PPC20 - RESPONSE TO REQUEST FOR FURTHER INFORMATION
HG REF: A2000079.00

Thank you for your memo dated 12 August 2022 in which you requested further information regarding Private Plan Change 20 – Airport Northern Precinct Extension. We have provided our responses to each request within the following table.

PRIVATE PLAN CHANGE 20 - TITANIUM PARK LIMITED AND RUKUHIA PROPERTIES LIMITED - AIPOPT NORTHERN PRECINCT EXTENSION

FIG 17 - REPRESENTATIVE VIEWPOINT 1

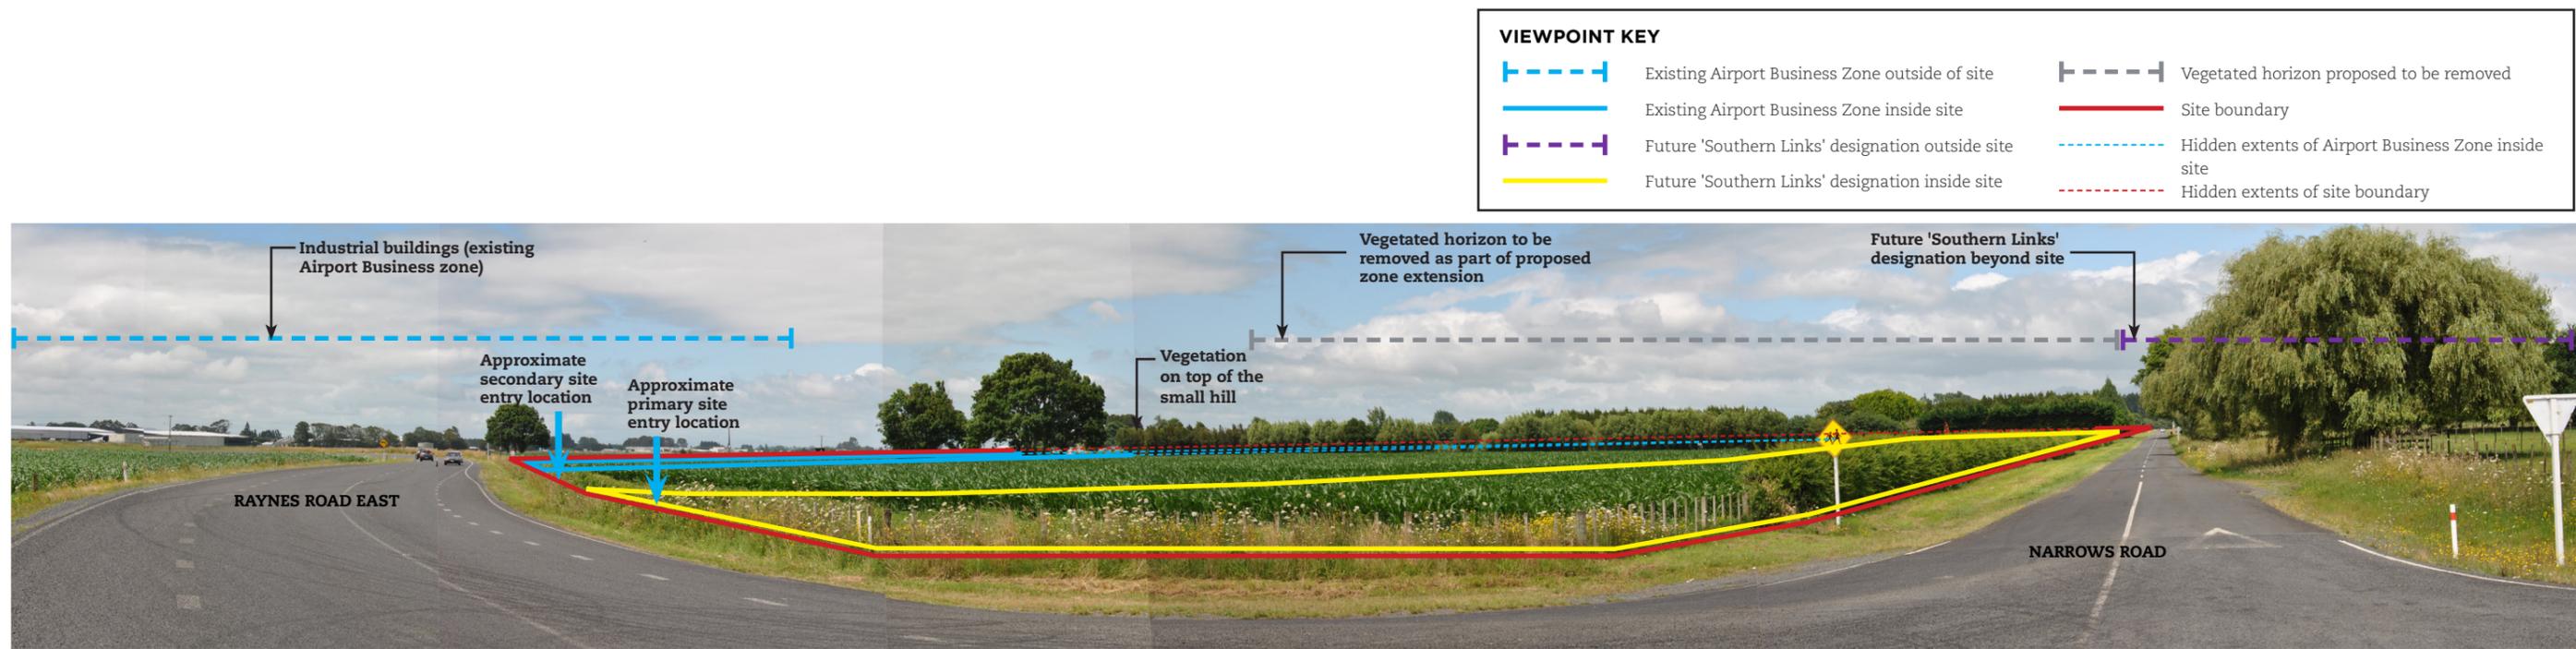
13	Visual Assessment a. Please provide a key with each viewpoint photo to outline the various linetypes, because their meaning is not always clear.	Please refer to Appendix A

VIEWPOINT KEY

Existing Airport Business Zone outside of site
	Existing Airport Business Zone inside site
	Airport and runway land
	Site boundary
